Annex G Insulating Fluids Subcommittee

**October 17, 2018
Jacksonville, FL**

G.2.1.1 C57.104 – IEEE Guide for the Interpretation of Gases Generated in Oil – Immersed Transformer (PAR Expiration: 12/31/19)

Review of main changes in Draft 5.1

Figure 1 (4.1) (Update)

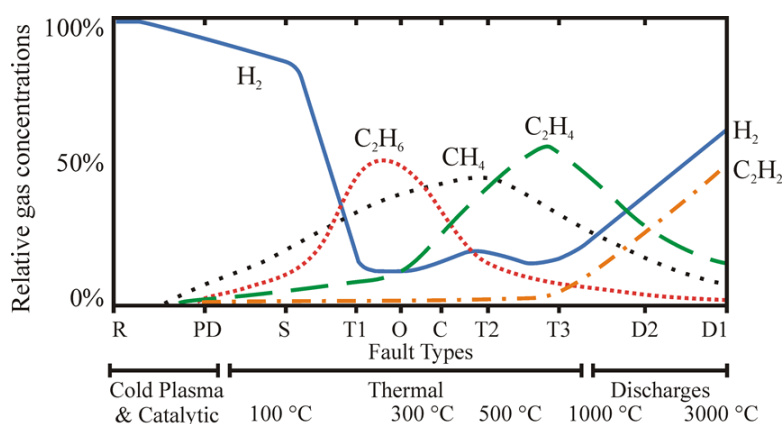
There was no objection to the proposed figure.

Concept of percentile (A.1) (Addition)

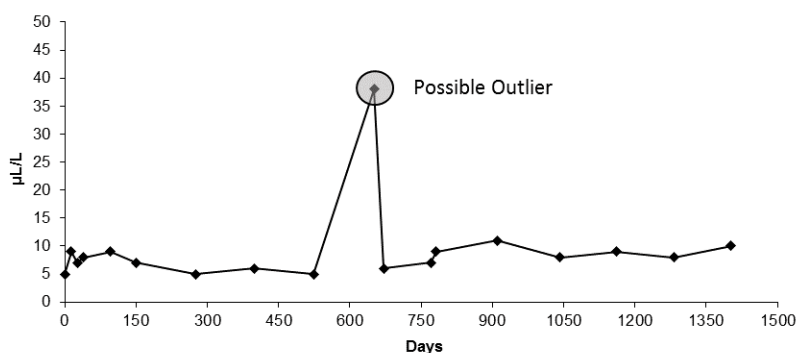
There was no objection to the proposed graphs and associated text.
